Equipment Safety Recall

N192217500 Tonneau Cover Retention

Revision: 02

Revision Description: This bulletin has been updated with additional dealer instructions in the Attention Box. Please discard all copies of N192217500-01.

5331771

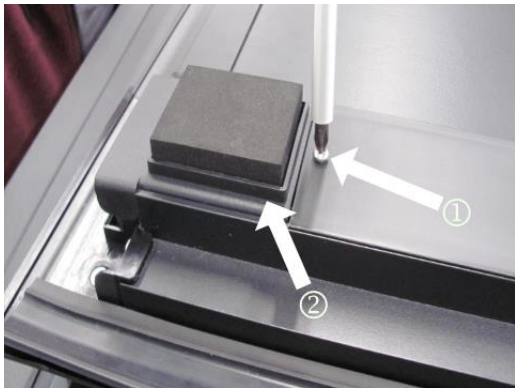
4. Install the new front lip seal (1), ensure the seal anchor (2) mates with the extrusion channel (3). Slide the seal across the full length of the channel, **ensure seal is centered** on the front panel.

5331776

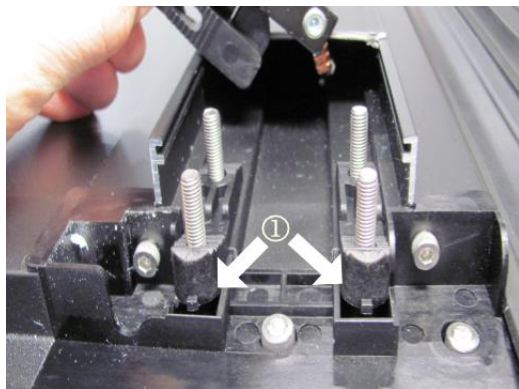
7. Remove the 4 nuts and 4 washers (1). Discard the nuts, retain the washers. Remove the latch plate (2) and U-shaped adjustment step (3) and set them to the side, a cable will remain attached to the latch.

5331777

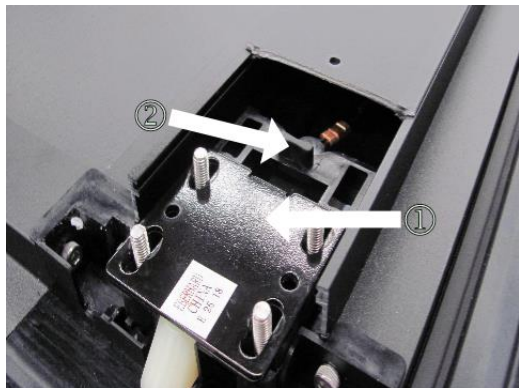
8. Remove the two existing lower adjusters and discard (1). Install the two new adjusters provided in the attachment kit.

5331778

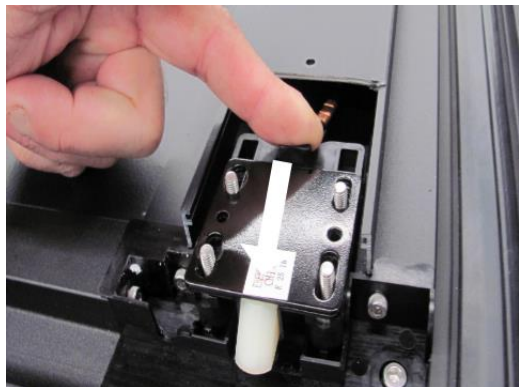
9. Reinstall the original U-shaped adjuster (2) and latch (1).

5331779

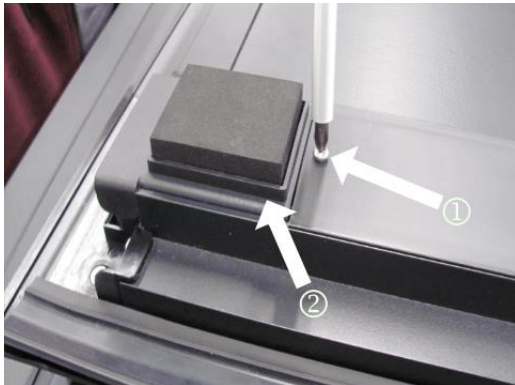
10. Set the latch to the correct (maximum) height, push on the inboard standing tab and slide the U-shaped adjustor to the full outboard position.

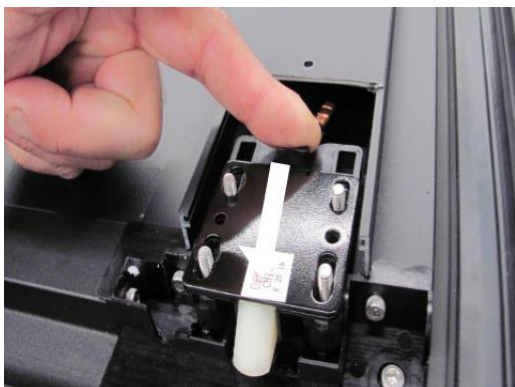
15. With the rear panel open, locate the right (passenger side) latch. Perform steps 6-12 at this location, **with one** exception.

- When reinstalling the U-shaped adjustor and latch, push on the inboard standing tab and slide the U-shaped adjustor to the full outboard position.

- While applying light finger pressure to the metal plate, push the adjuster inboard two steps. You should be able to feel the two steps as well as hear a “click” type sound.
- With pressure still applied to the metal plate, install the 4 existing washers along with the 4 new nuts supplied with the attachment kit. Tighten the 4 nuts to 1Nm (9 lb.-in).

5331793

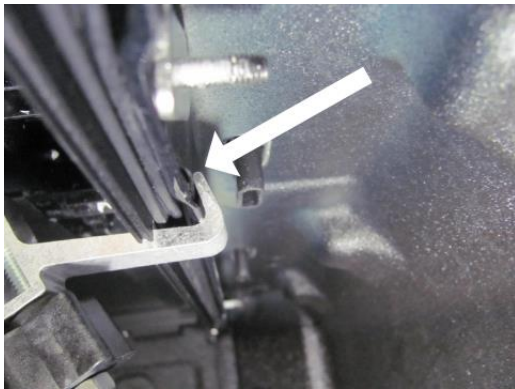
18. Install the two new thumbwheel fasteners and washers supplied with the attachment kit. Ensure the raised side of the fastener (1) and conical side (2) of the washer are facing the clamp.
